# Service Bulletin

Bulletin No.: 19-NA-137

**Subject: Squeak Noise From the Vehicle Underbody**

5360283

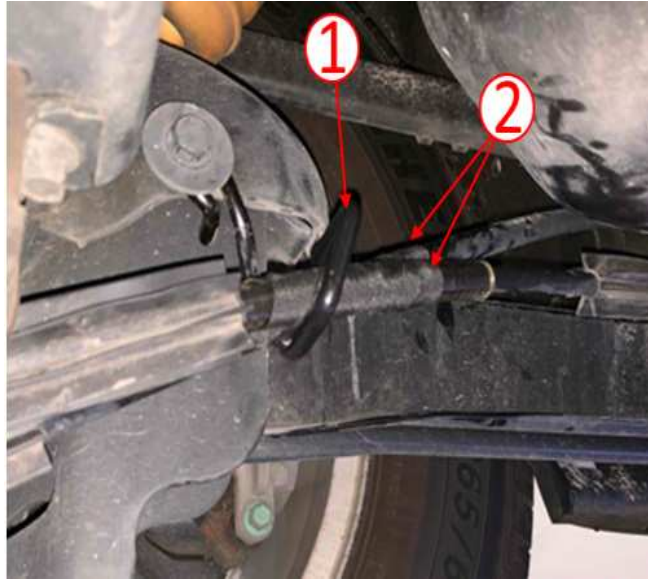
<b>Involved Region or Country</b>	North America, Russia, Europe, Middle East, Israel, South America, Japan, South Korea and Thailand.
<b>Condition</b>	Some customers may comment that a squeak noise can be heard from under the vehicle while driving at slow speeds.
<b>Cause</b>	This condition may be caused by the parking brake cables rubbing against each other or alongside the body.

**Note:** Ensure that the tape extends at least 25 mm (1 in) above and below the rubbing point at the parking cable bracket or the body.

Using Woven Polyester Electrical Tape (PET), locate both of the brake cables near the parking brake cable bracket (1) and apply tape (2) to the cables ensuring that the tape is applied in a double layer extending along the cable as shown above.
